RESPONSE TO REQUEST FOR ADDITIONAL INFORMATION

APR1400 Design Certification

Docket No. 52-046

RAI No.: 390-8479
SRP Section: 12.02 – Radiation Sources
Application Section: 12.02
Date of RAI Issue: 02/01/2016

Figure 1. Location of CR Emergency ACUs above the MCR

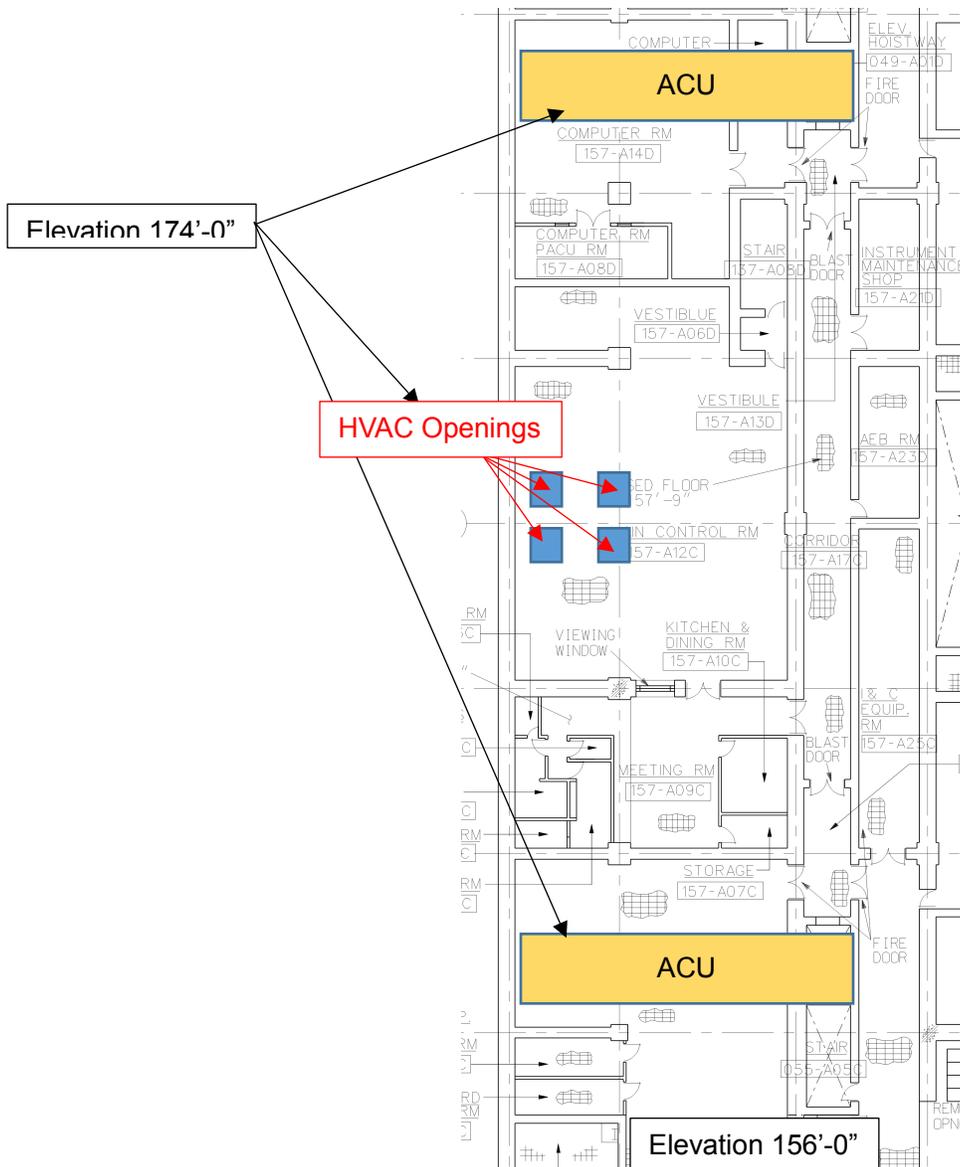
3. In the response, the applicant provides information indicating that containment penetrations will not be a significant dose contribution to CRE dose. Please specify if the design is such that it prevents a direct radiation streaming path or near direct radiation streaming path from the emergency filters (located above the main control room.) into the CRE through the ventilation ducting openings or other penetrations into the CRE.

3. The two control room emergency air cleaning units, at elevation 174'-0", are not located directly above the main control room (MCR) at elevation 156'-0"; one is located above the computer room (plant north side of the MCR), and the other above the TSC room on the south side of the MCR. Their locations are indicated in the attached sketch (Figure 1) for illustration purposes. Based on these locations, the air supply and exhaust duct penetrations are designed to be located away from the CR Emergency ACU to prevent direct, or near direct, radiation streaming pathways.
